## MEMORANDUM

**TO:** PLANNING COMMISSION  
**FROM:** EVAN C. GARIEPY – PLANNER  
**SUBJECT:** REQUEST FOR VARIANCE #V1-2026 TO REDUCE FRONTAGE TREE SCREENING REQUIREMENTS AND TO PERMIT PLANTING TREES WITHIN AN EASEMENT ON LOTS 4 AND 5, BLOCK 2, NEW PRAGUE BUSINESS PARK 11<sup>TH</sup> ADDITION.  
**DATE:** FEBRUARY 19TH, 2026

3. The applicant's proposed landscaping plan. Dated 02/02/2026, staff notes 02/10/2026.

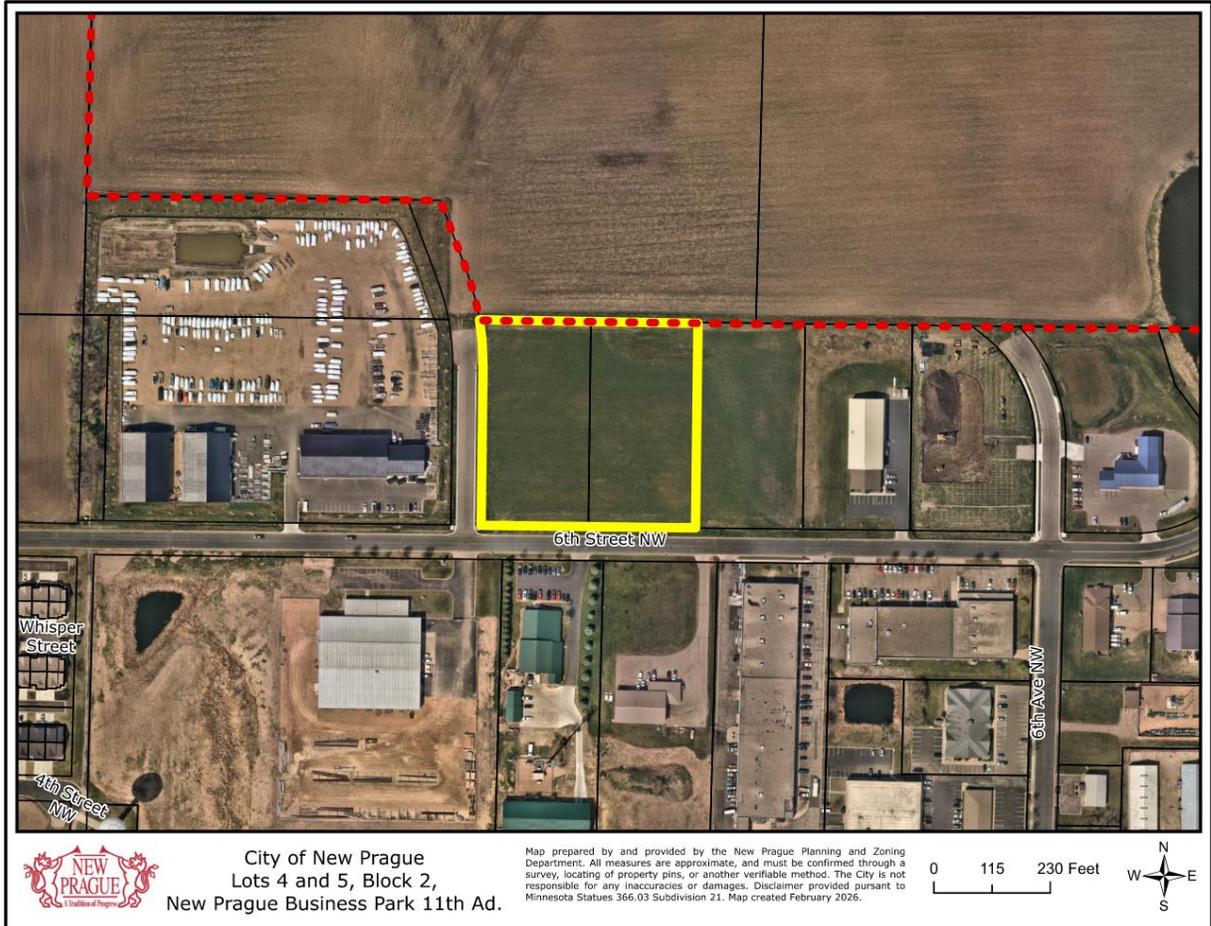
North easement: There are concerns with this due to trees being near a storm sewer line and potentially reducing access. Ultimately it's an issue regarding maintenance of the stormwater line and the easement still exists and the trees will be moved as far away from the stormwater line itself. Staff suggests adding a condition about removal and replacement of the trees in easements if work is necessary in the future.

East easement: The single tree in the easement should be moved west by 1 foot, meaning that there is no landscaping in this particular easement.

South easement: Reimers confirmed that the fiberoptic line is 12' deep, and should not be an issue with landscaping. The trees proposed here are smaller, and likely shouldn't be as big of an issue as full-sized trees would be. Landscaping and grading must accommodate a future trail.

West easement: All trees are approximately 3' into the easement, leaving approximately 7' between the landscaping and existing sidewalk. Reimers stated that they may need to install an electrical conduit or to utilize underground boring when access is eventually required.

- a. The developer must grade the south right-of-way to accommodate a future trail.
  - b. A grading plan must be provided prior to the approval of this variance.

- c. If access to the easement is required, the City must be reimbursed for the trimming or removal of any landscaping. The applicant is also responsible for replacing the removed landscaping at their own expense.)

- d. The property owner is responsible for any damage to the storm drain tile line behind the curb caused by tree roots should maintenance or repair be necessary in the future.
